Design Review Board Meeting

**111 WEXFORD CLUB
DRIVE
FINAL REVIEW
AUGUST 13th, 2024
DRB-001088-2024**

**111 WEXFORD CLUB
DRIVE
PROJECT NARRATIVE
&
WEXFORD HOA
APPROVAL
&
DRB COMMENTS AND
RESPONCES**

Project:	Project No.
Wexford Clubhouse Renovations & Additions	24001
111 Wexford Club Drive	Date: 5/6/2024
Hilton Head Island, SC 29928	Submittal: HHI Conceptual Review

2 NORTH ELEVATION 1
3/16" = 1'-0"

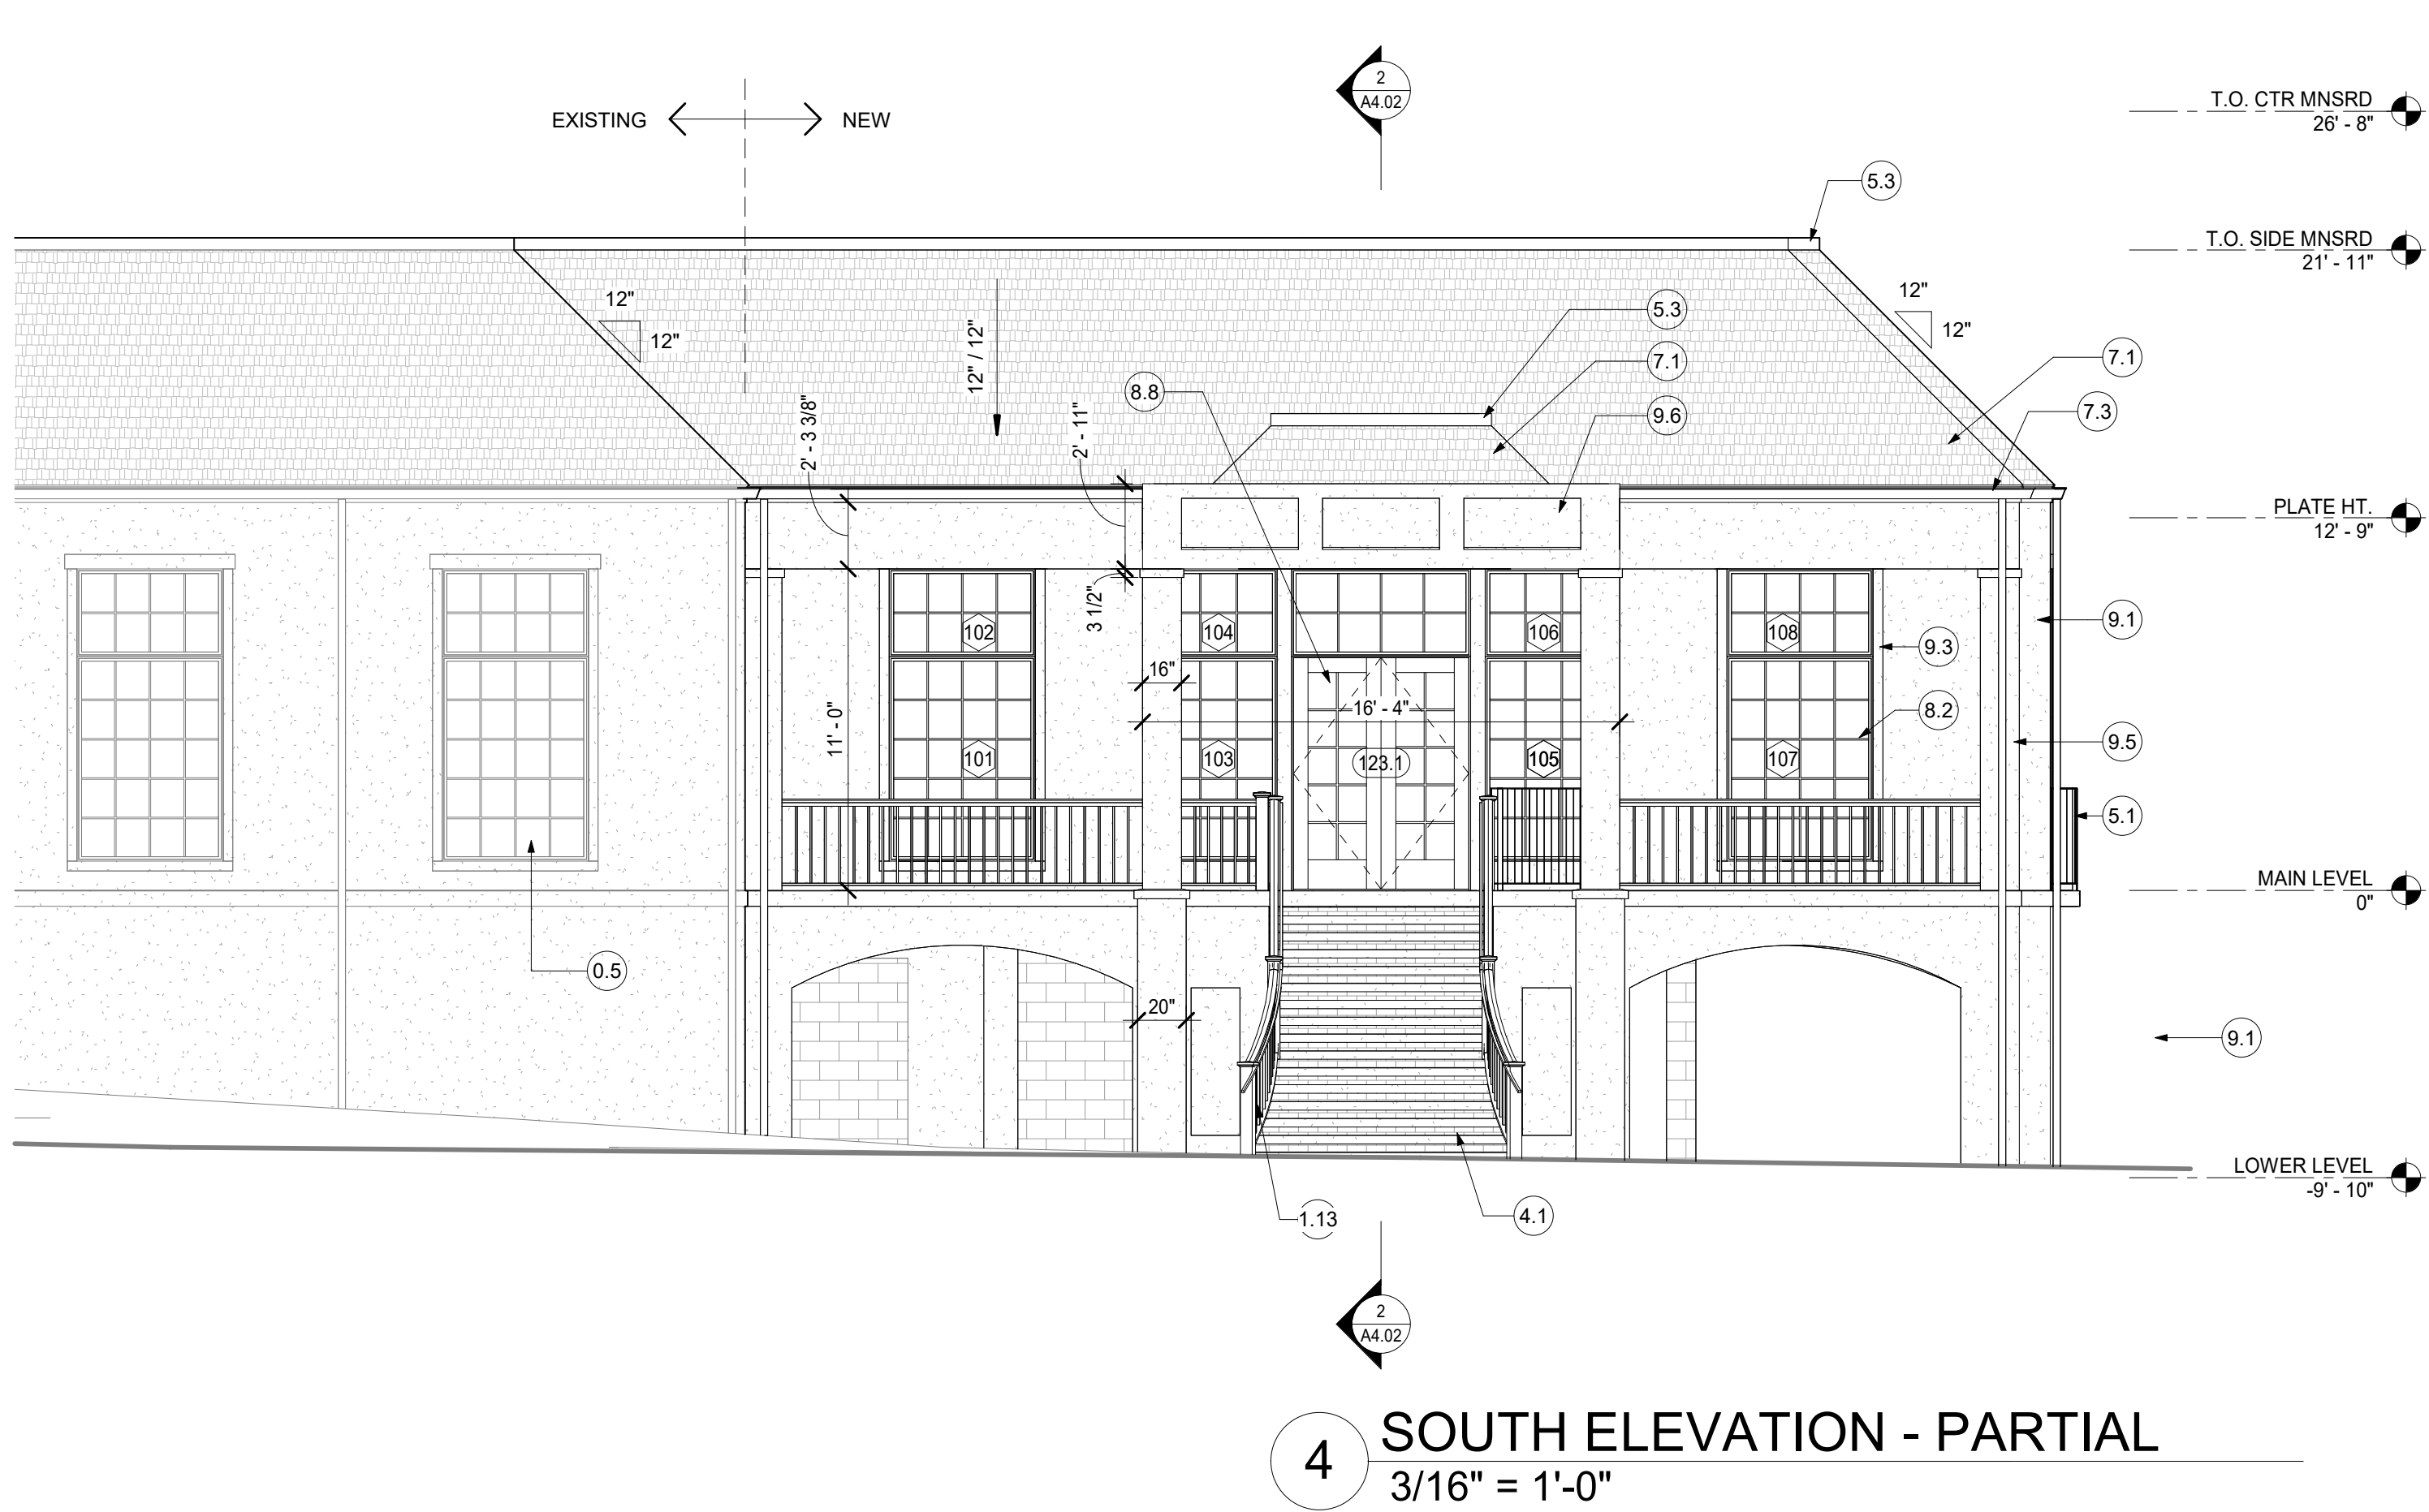
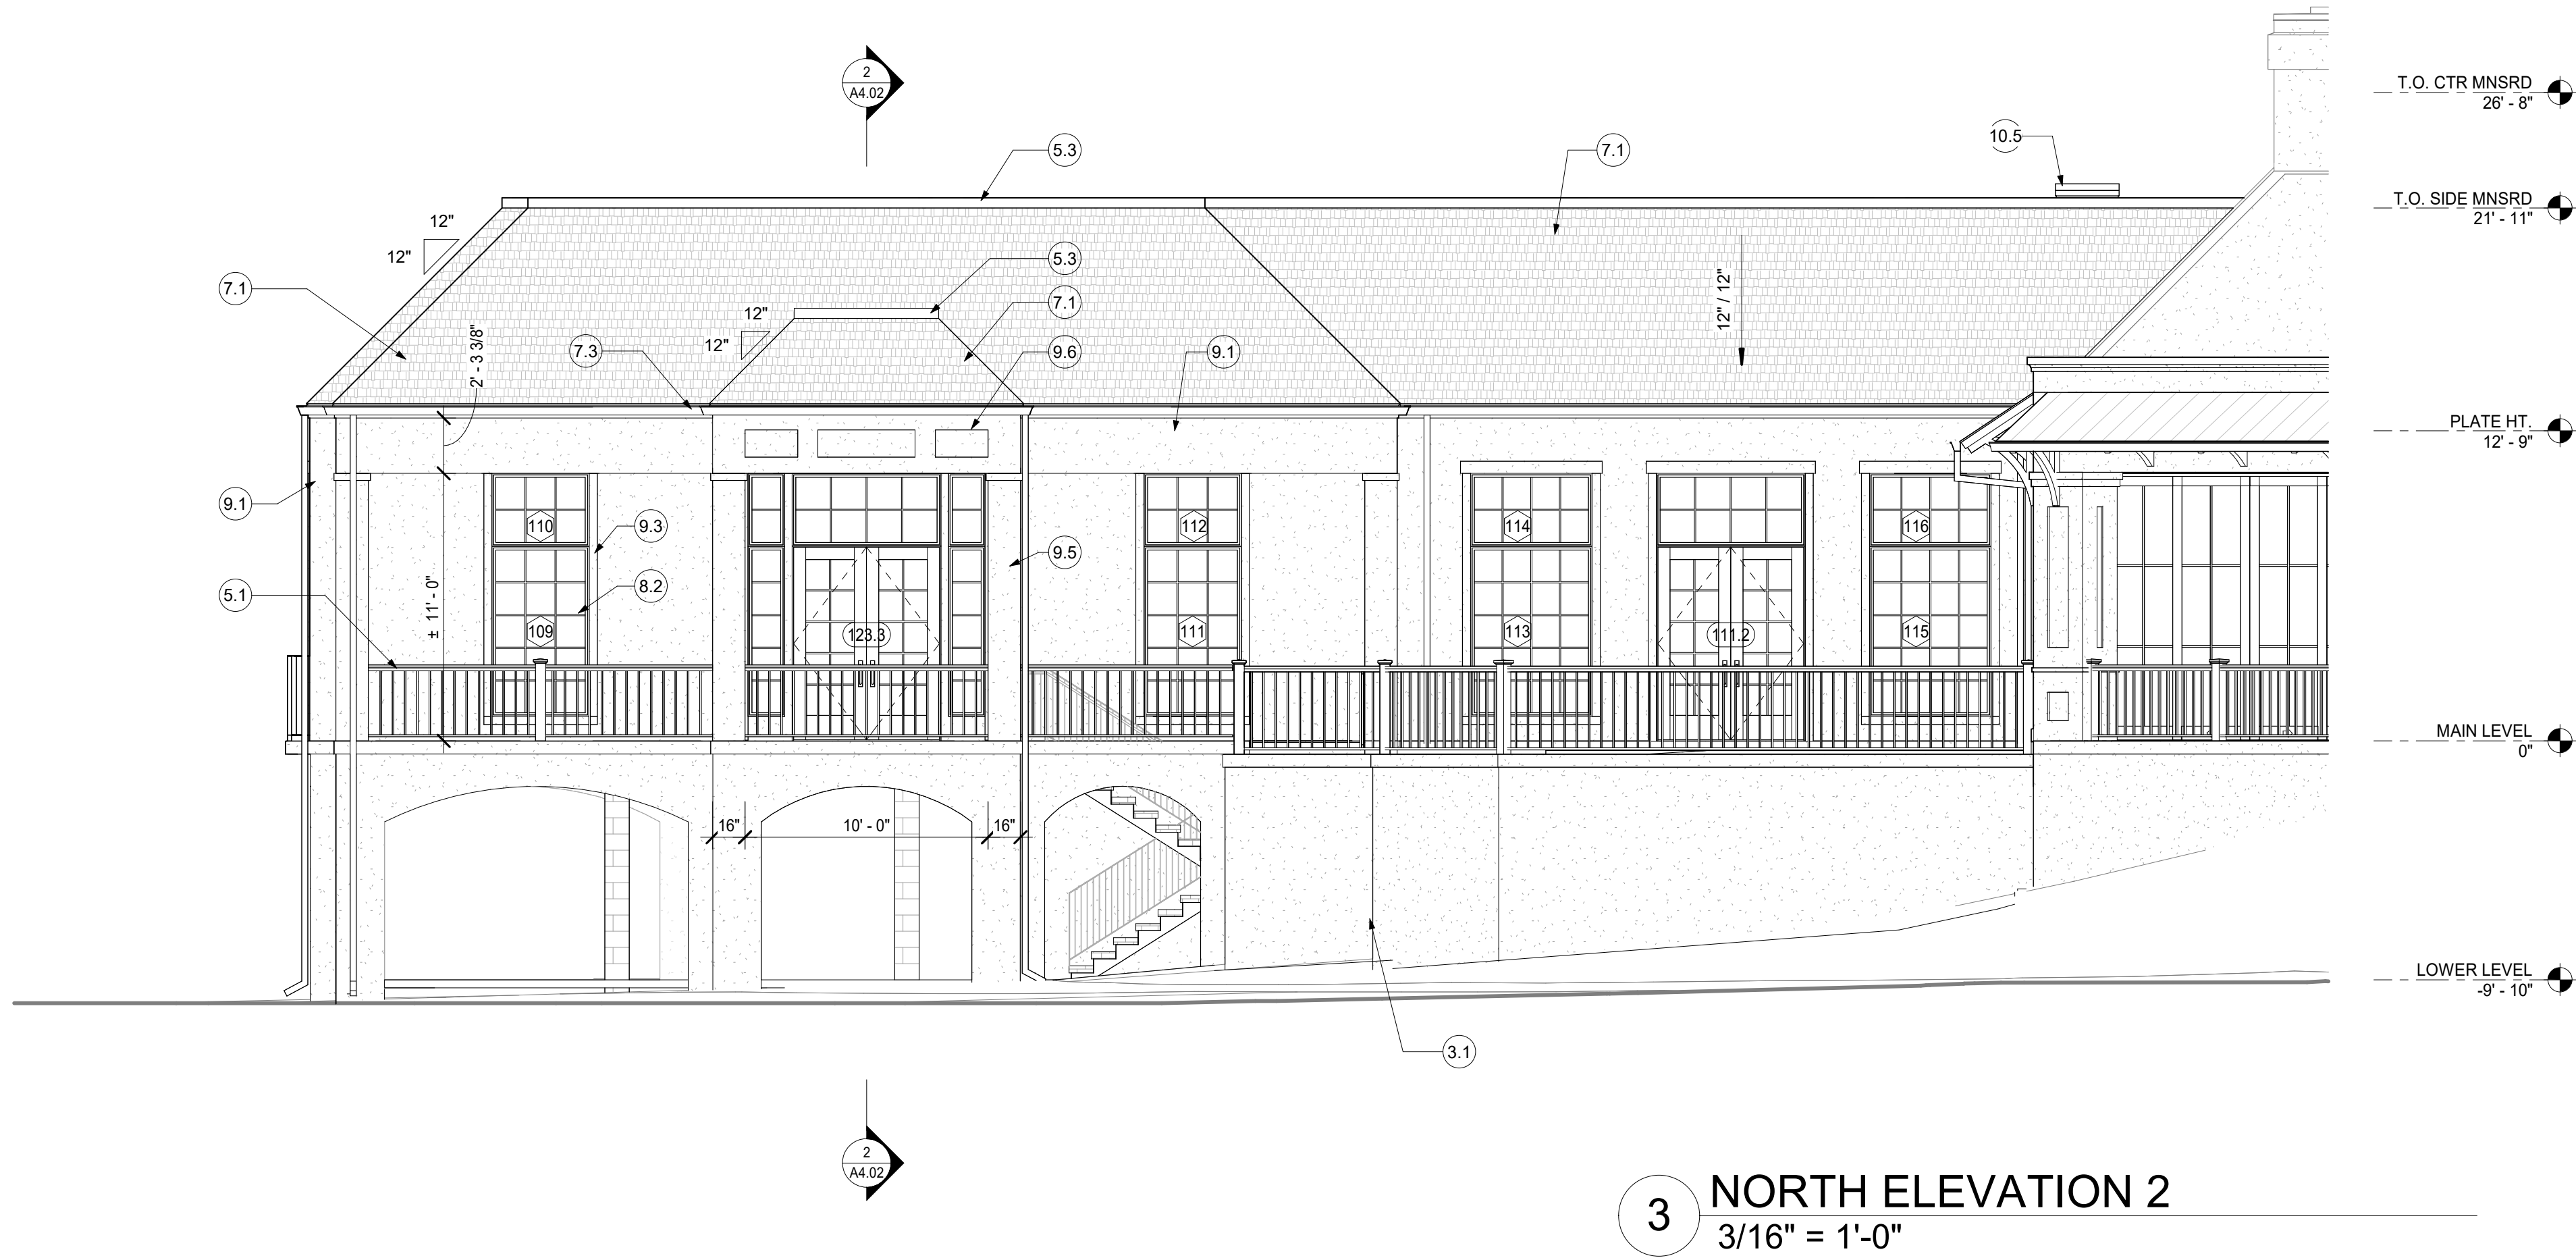
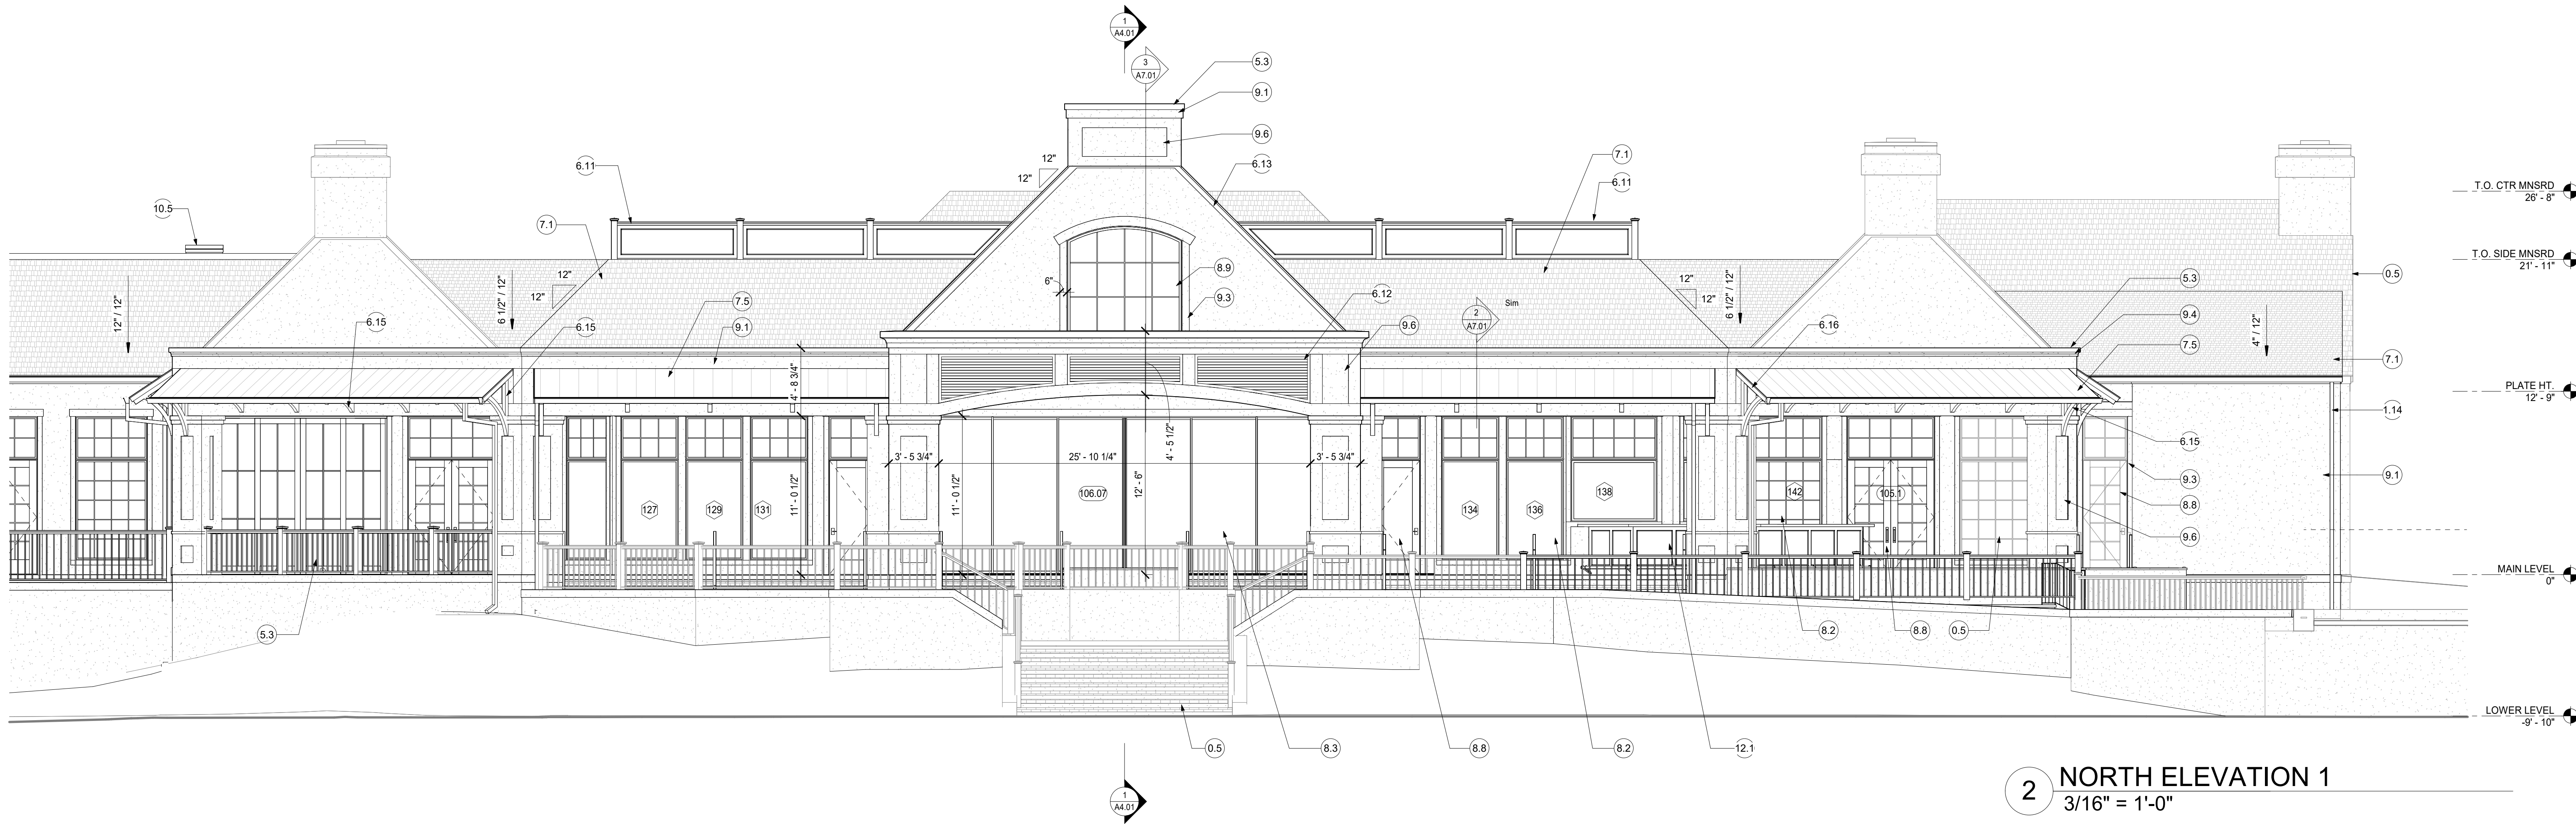
- a. **Narrative:** This has been updated on the landscape plans.
5. **DRB comment:** "Study the scale of the small metal roofs. Associated primarily with the rear near the porch."

- a. **Narrative:** The small metal roofs have been changed to wood framing supported by thick timber brackets. The brackets at the ends of the roofs extend down the wall/pilaster, and the intermediate brackets are mostly under/behind the roof (when seen in an elevation drawing). We appreciate this comment and think this is a good change to keep the detailing more in scale with the rest of the composition. These can be seen in the elevations, details, and renderings.
